Idler Pulley Installation and Belt Replacement

Constellation
Heritage
> 4700 Models

Western Star
Service Bulletin

Fig. 1, P-Clamp Mounting Hole

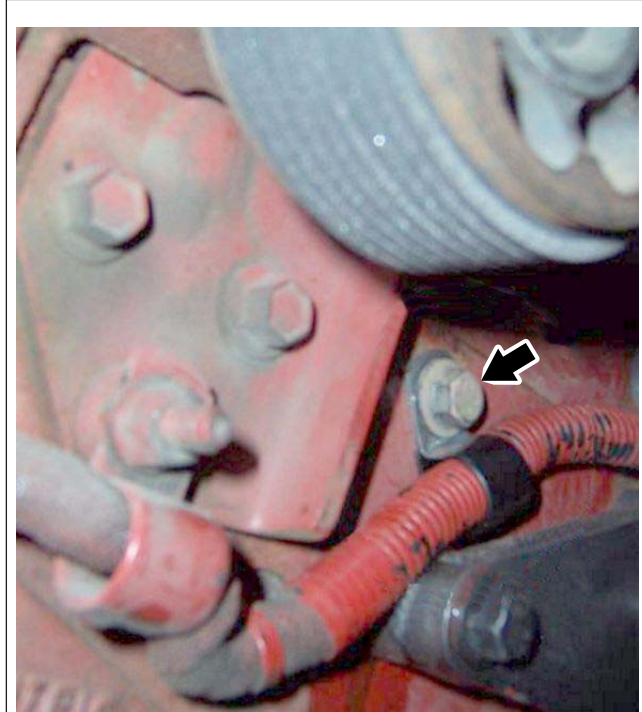
4. Install the idler pulley and bracket.
 - 4.1 Clean the unused holes in the front of the engine that will be used when installing the harness P-clamp and the new idler pulley bracket. See [Fig. 1](#).

Clean this hole.

Fig. 2, Moving the P-Clamp

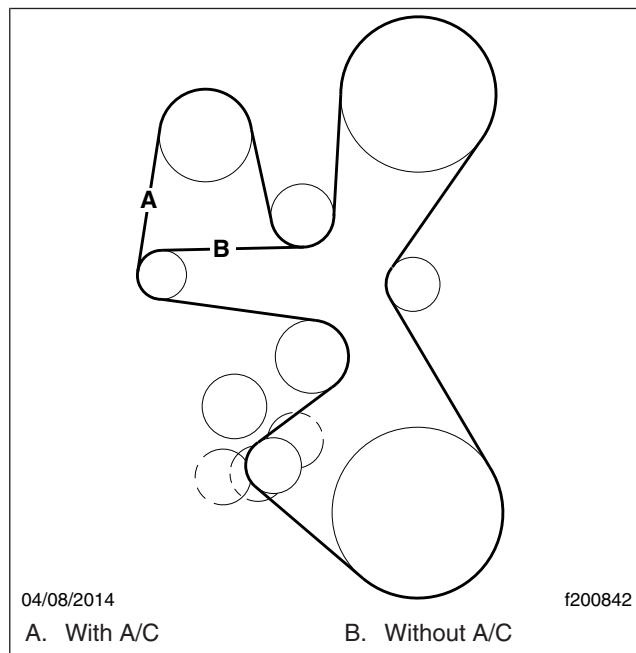
- 4.2 Remove the factory-installed P-clamp securing the harness, and position it in the unused hole toward the center of the engine. See [Fig. 2](#).
 - 4.3 Install the new idler pulley bracket. Tighten the capscrews 32 lbf-ft (43 N·m).

Locate the P-clamp here.

- 4.4 Install the new idler pulley on the bracket. Tighten the capscrew 32 lbf-ft (43 N·m).
5. Install the new serpentine drive belt. See [Fig. 3](#).
6. If equipped, connect the FEPTO drive shaft to the engine pulley.
